## **Coombe Bissett (SBR PC 39)**

**Table 36 Proposed changes to the pre-submission Coombe Bissett Settlement Boundary<sup>42</sup>**

**Coombe Bissett  
Proposals for Revised Settlement Boundaries  
Proposed Change SBR PC39**

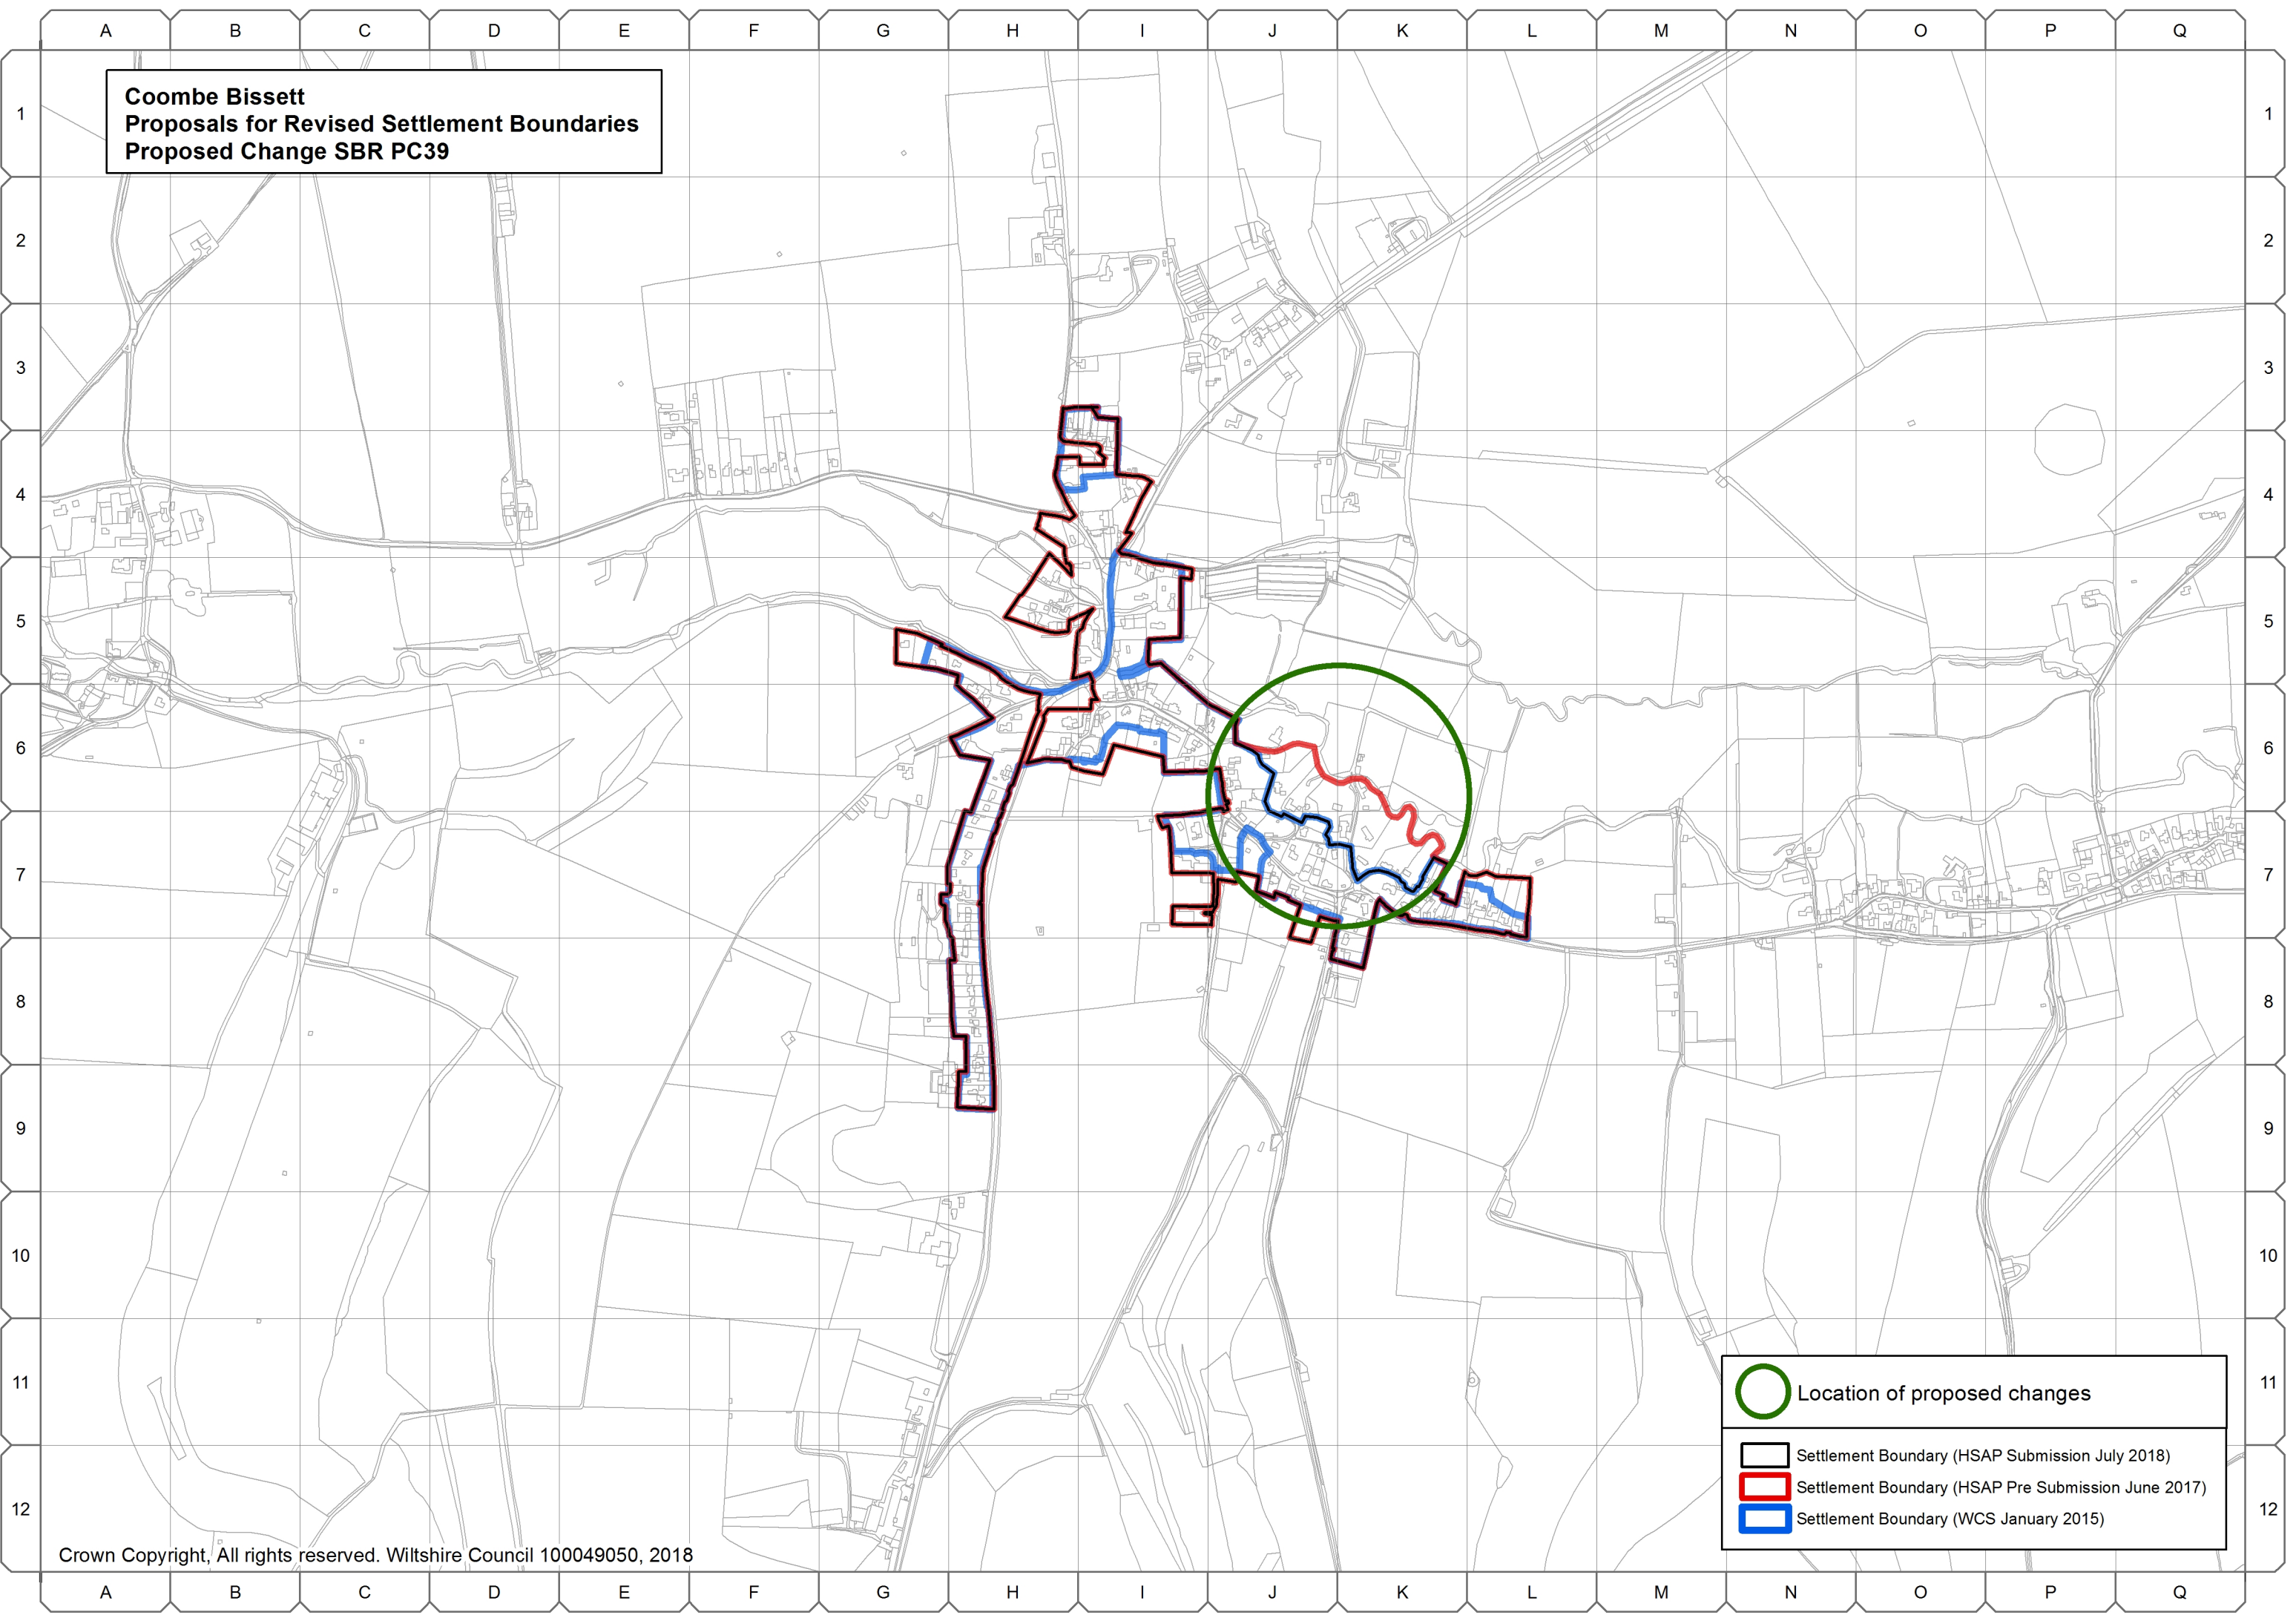
<b>Map Grid Reference</b>	<b>Proposed change</b>
J6, K6, <u>J7</u> , and K7	Amend pre-submission settlement boundary to retain the existing settlement boundary and exclude these properties and gardens. This is the extended curtilage of properties that relates more closely to the open countryside and has the capacity to substantially extend the built form of the settlement in terms of scale and location, i.e. further into the flood plain.
